the eight one five pine

815 Pine Street
Denny Triangle Urban Center Village
DPD Project # 3007151

Recommendation Meeting Goal:

Obtain final DRB approval to allow the project to move forward to construction.

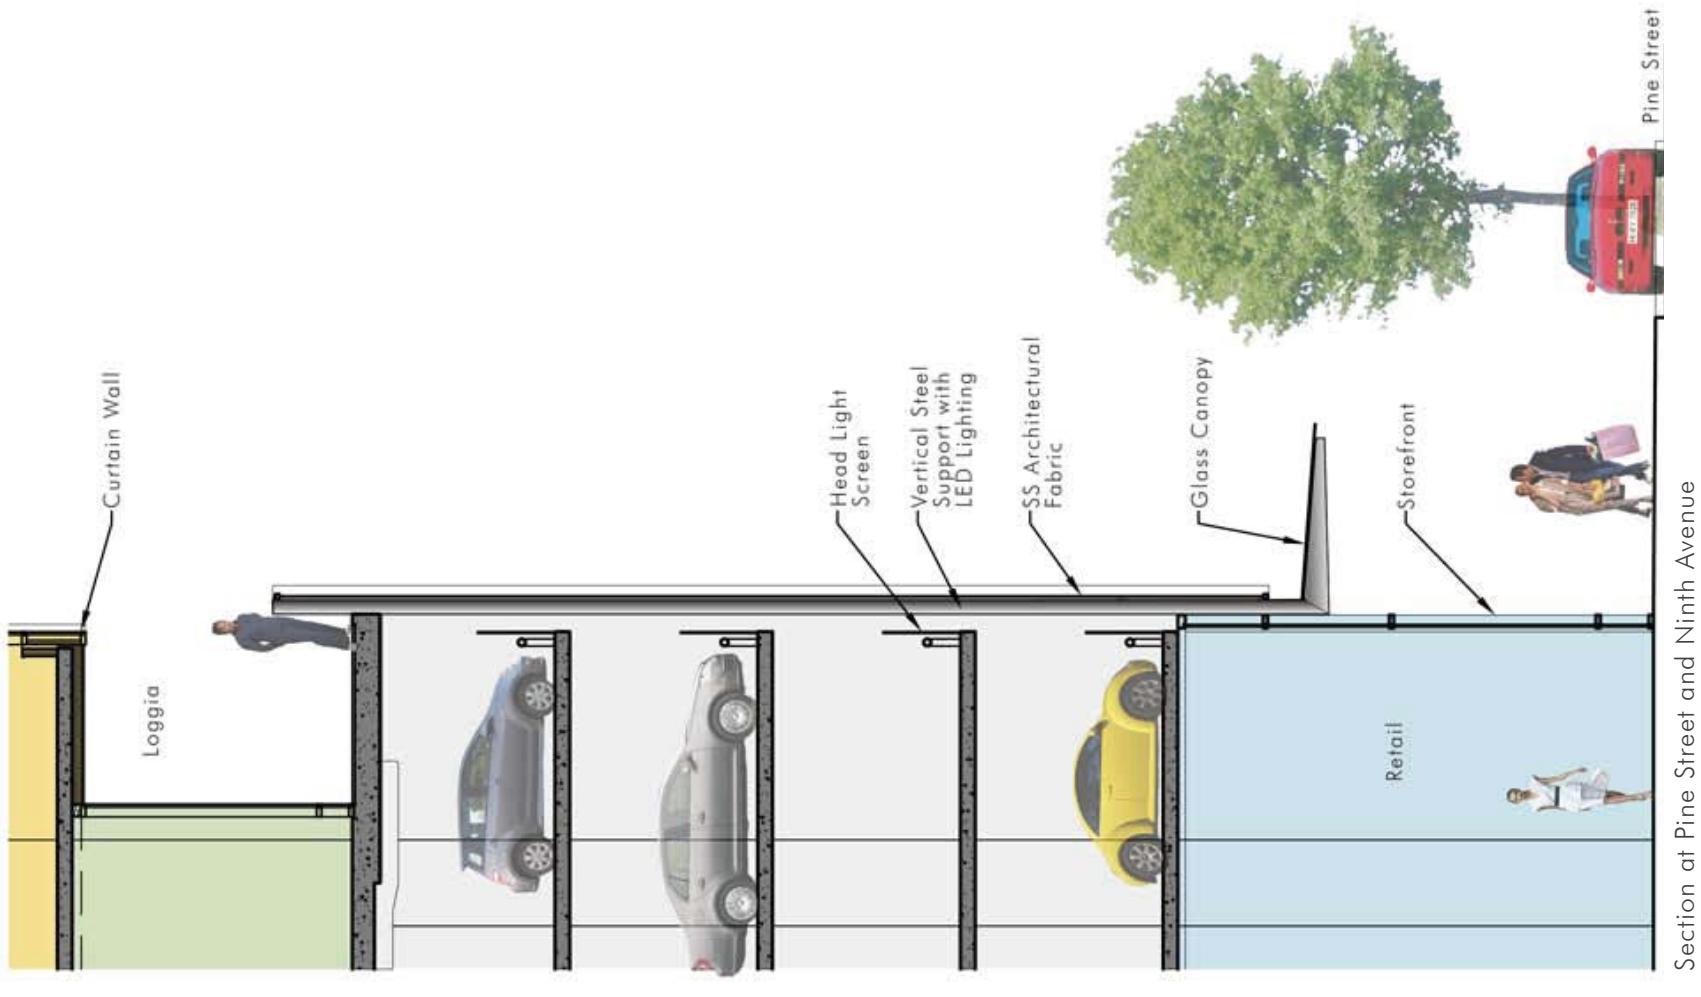
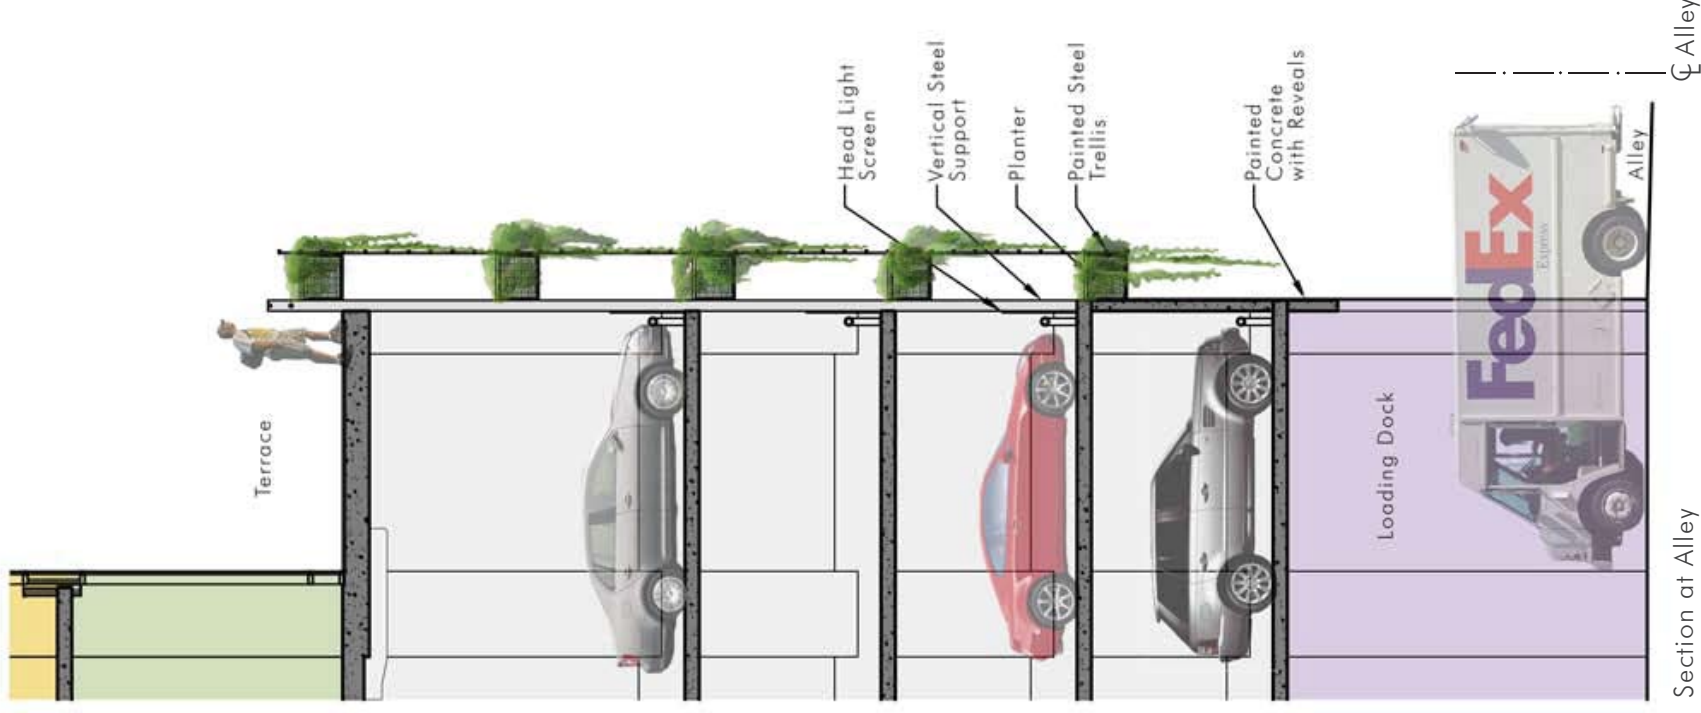
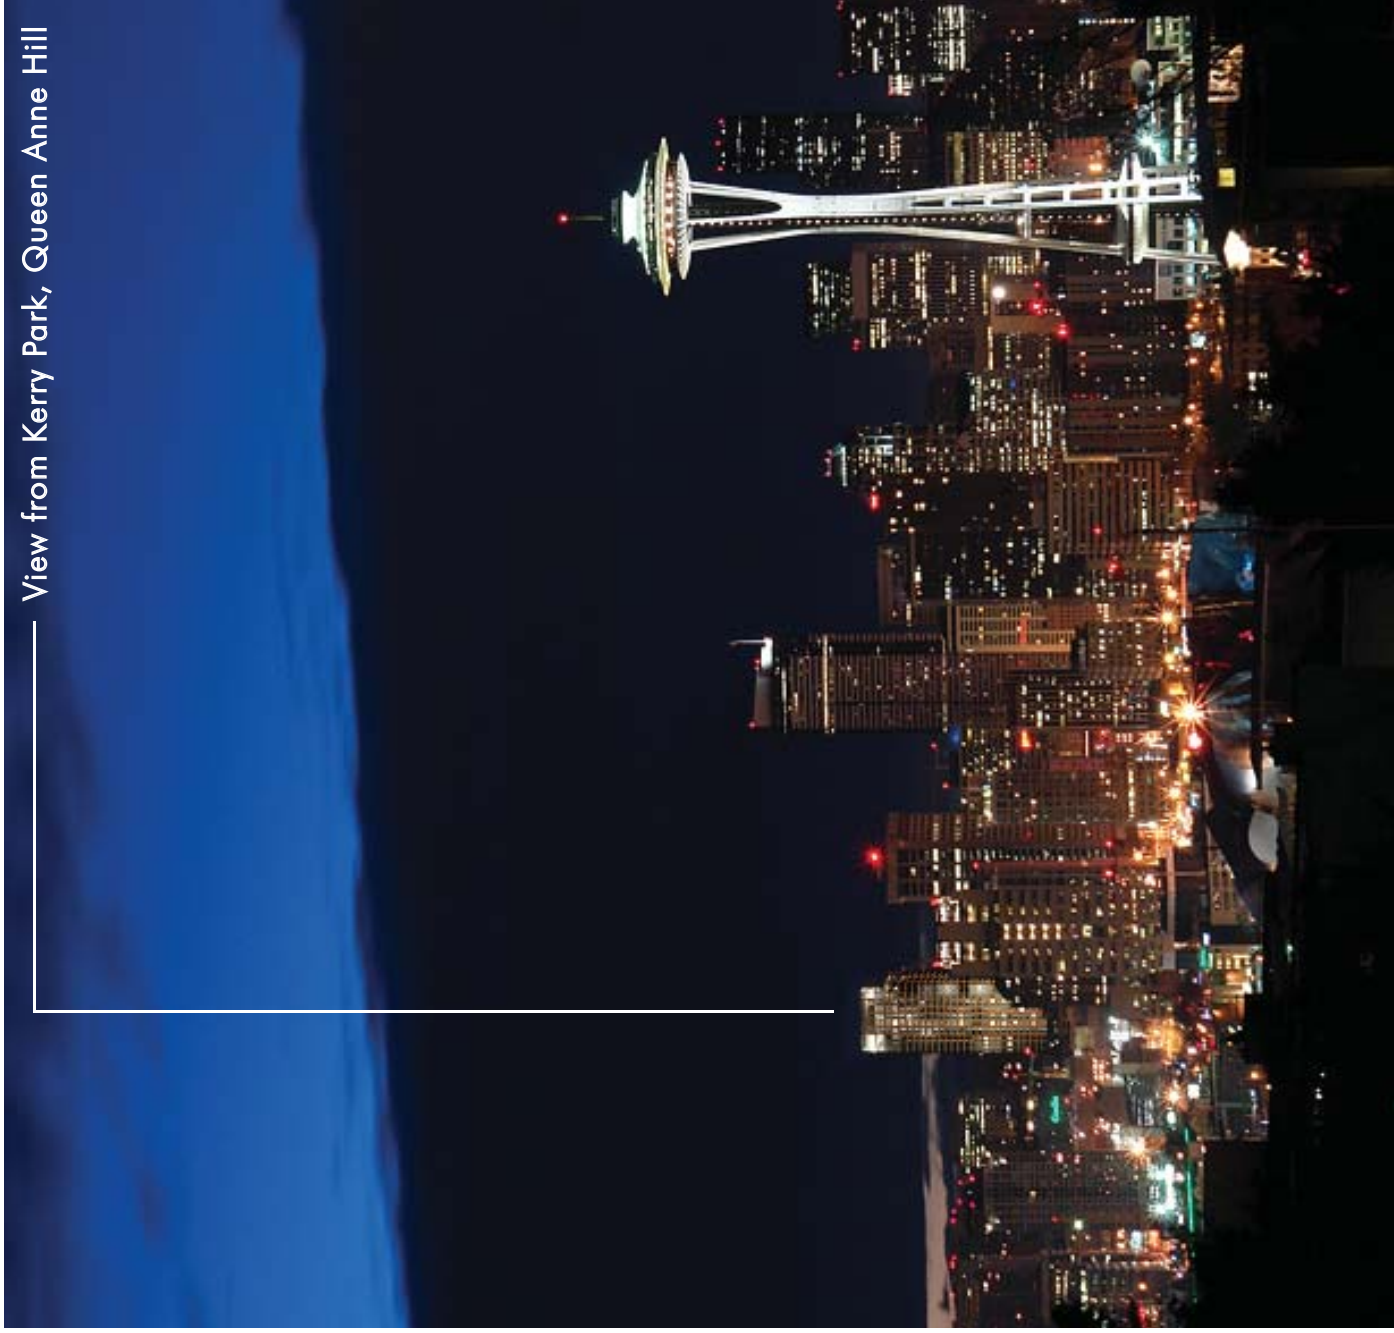
DRB Comments – Intrigued by the potential of channel glass for the façade of the parking garage, the Board urged the architect to extend the investigation of what the material’s possibilities are. The Board would like a list of local examples of where channel glass has been used. Follow-up drawings should show a realistic night rendering of the glass and the open separations between panels explaining how headlamps and overhead garage lighting will be addressed by the channel glass.

Response – Two distinct parking screen concepts are provided. At the public street sides of Pine and Ninth a stainless steel architectural mesh is provided. The design provides a vertical emphasis consistent with the overall design concept for these elevations and the attachment details will provide interesting scale. The depth of the mesh restricts views from the sides and sidewalk below. A dramatic planted green screen wall is provided at the alley elevation on the west side of the building. This green wall will utilize previously grown vines that allow for the screen to be installed in a substantially compete condition.
